R44

SERVICE BULLETIN SB-30

SUBJECT: Auxiliary Fuel Tank Drain Tube Shutoff Clamp

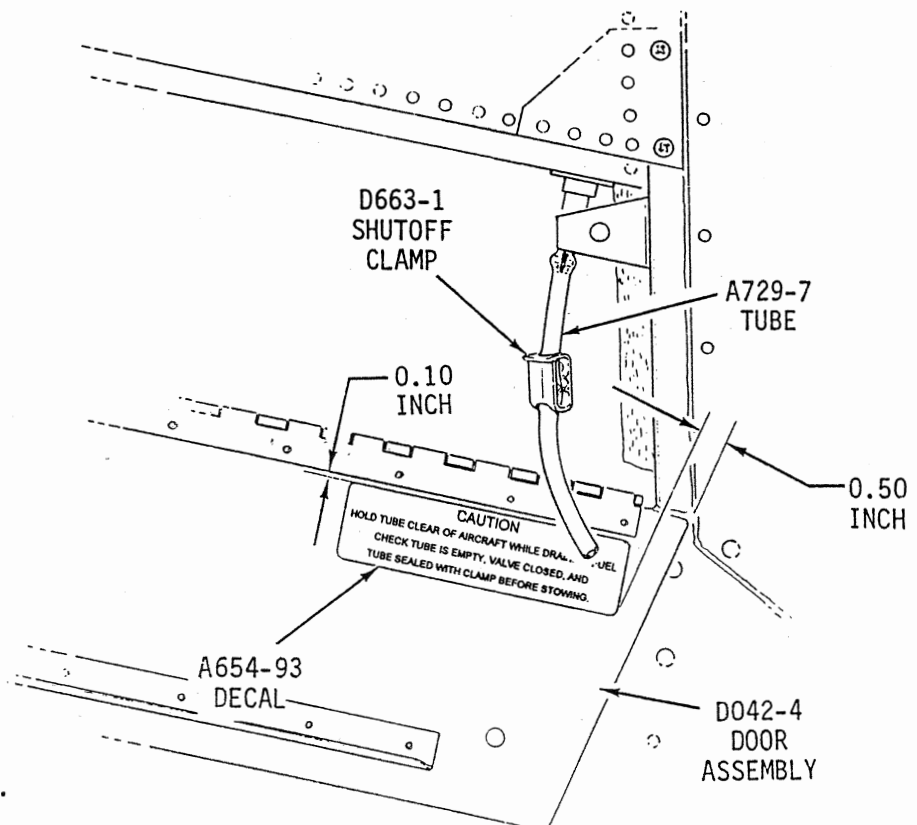
BACKGROUND: RHC has added a shutoff clamp to the auxiliary fuel tank drain tube as a redundant seal when the tube is stowed for flight and a decal to ensure proper use of the auxiliary tank drain.

Open D663-1 shutoff clamp and slide onto A729-7 tube as shown. (It may be necessary to deflect clamp open slightly for tube to enter.) Install A654-93 decal as shown. (Shutoff clamp and decal are enclosed. Additional shutoff clamps and decals may be ordered from RHC customer service.)
